AMENDMENT OF SOLICITATION/MODIFICATION OF CONTRACT				1. CONTRACT ID CODE		PAGE OF PAGES 1 2	
2. AMENDMENT/MODIFICATION NO. 0006		3. EFFECTIVE DATE 16-Nov-2001		4. REQUISITION/PURCHASE REQ. NO. W26GLG11705486		5. PROJECT NO.(If applicable)

14. DESCRIPTION OF AMENDMENT/MODIFICATION (Organized by UCF section headings, including solicitation/contract subject matter where feasible.) FY02 DORMITORIES, LANGLEY AIR FORCE BASE, LANGLEY, VA							
<small>Except as provided herein, all terms and conditions of the document referenced in Item 9A or 10A, as heretofore changed, remains unchanged and in full force and effect.</small>							
15A. NAME AND TITLE OF SIGNER (Type or print)				16A. NAME AND TITLE OF CONTRACTING OFFICER (Type or print)			
15B. CONTRACTOR/OFFEROR _____ (Signature of person authorized to sign)		15C. DATE SIGNED		16B. UNITED STATES OF AMERICA BY _____ (Signature of Contracting Officer)		16C. DATE SIGNED 16-Nov-2001

Langley Airforce Base FY-02 and FY-03 1+1 Dormitory

Amendment 4

RFP2
.1

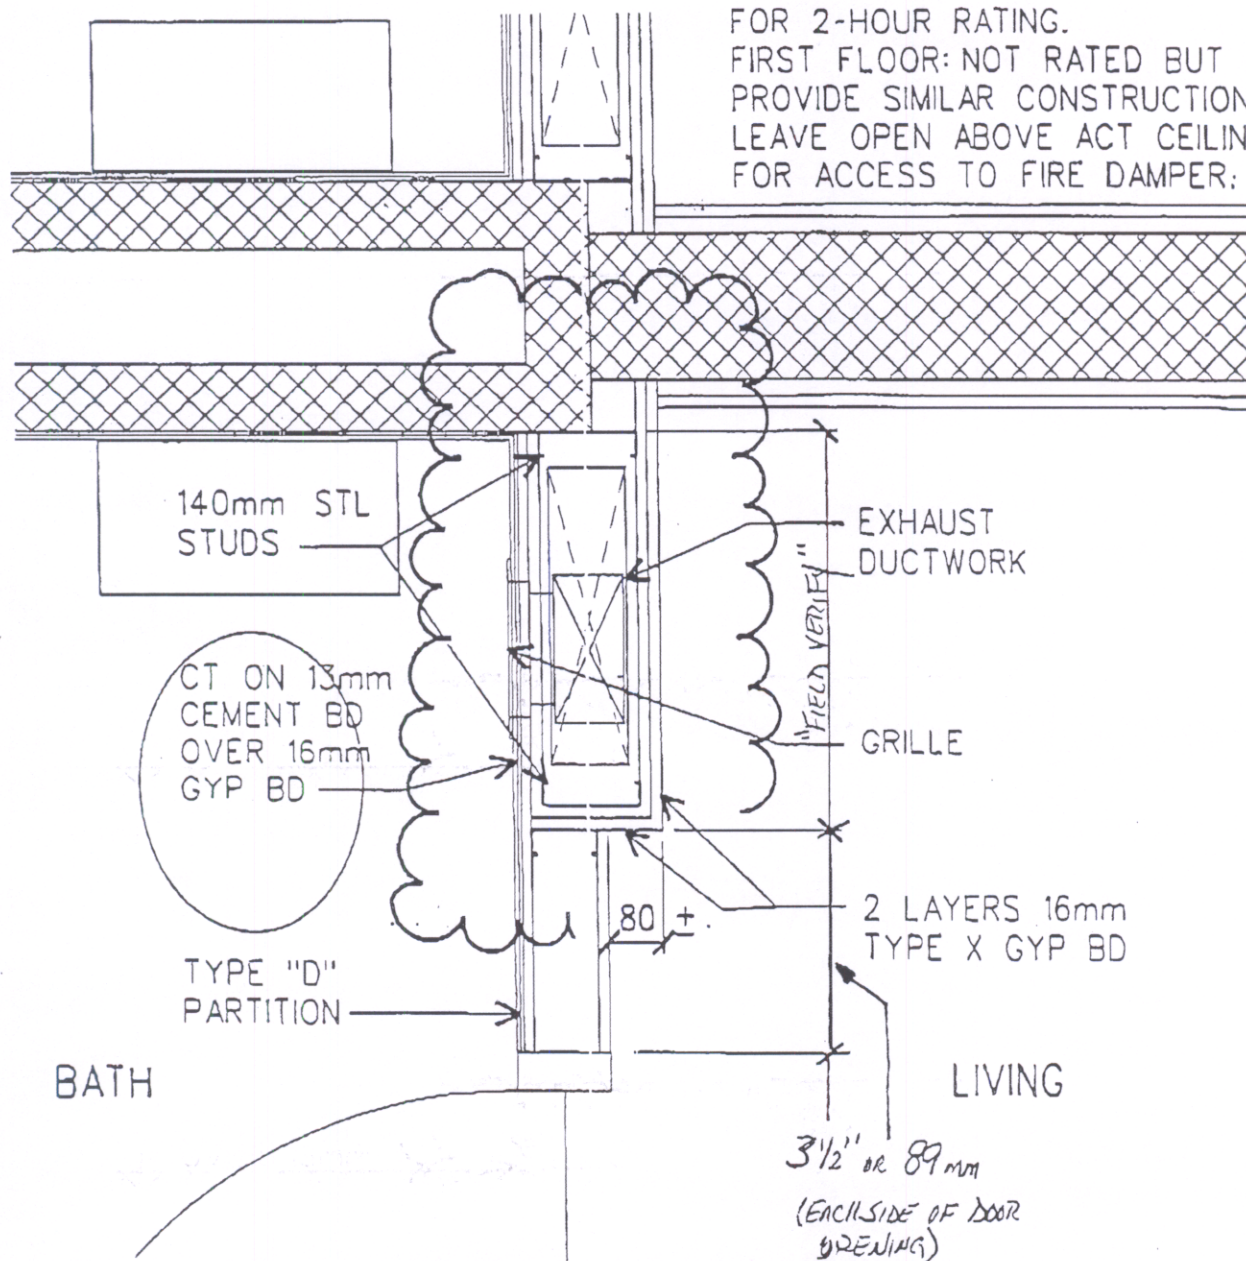
RFP2.1, SKM-1, SKM-2-FIRE DAMPER- Add fire dampers to the exhaust duct risers for each bathroom stack, and change the walls around the exhaust duct riser to provide a two hour rated shaft. See attached sketches.

FABRICATE PARTITION AROUND
EXHAUST DUCTWORK PER UL U425
FOR 2-HOUR RATING.
FIRST FLOOR: NOT RATED BUT
PROVIDE SIMILAR CONSTRUCTION.
LEAVE OPEN ABOVE ACT CEILING
FOR ACCESS TO FIRE DAMPER;

U.S. AIR FORCE ACC MCP PROJECT SIGN DETAILS

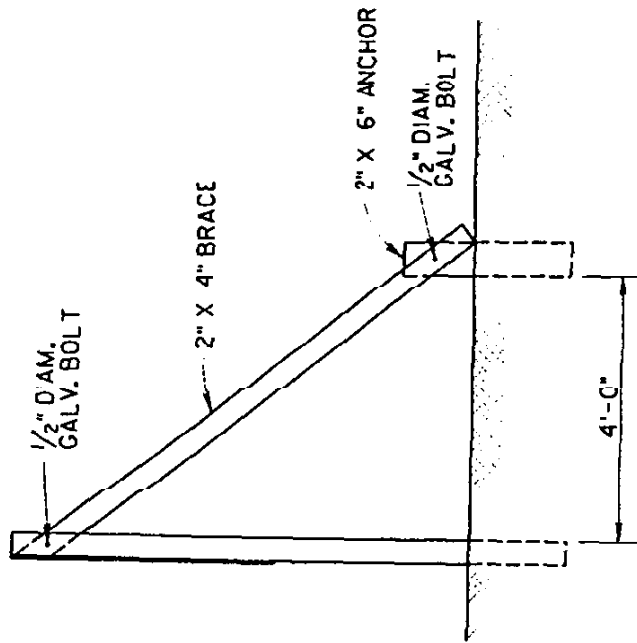
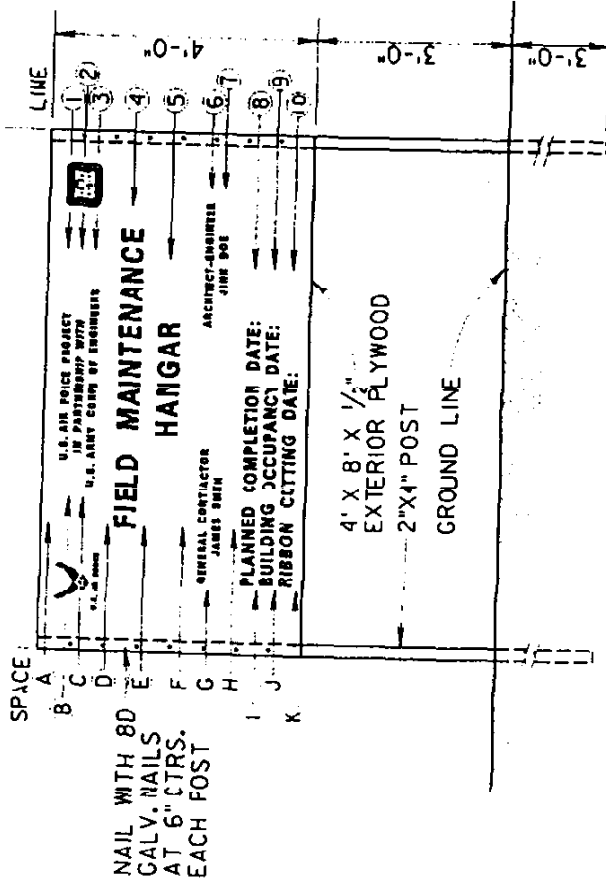
PROJECT SITE SIGN-Provide one sign as indicated in the sketch. See attached sketch.
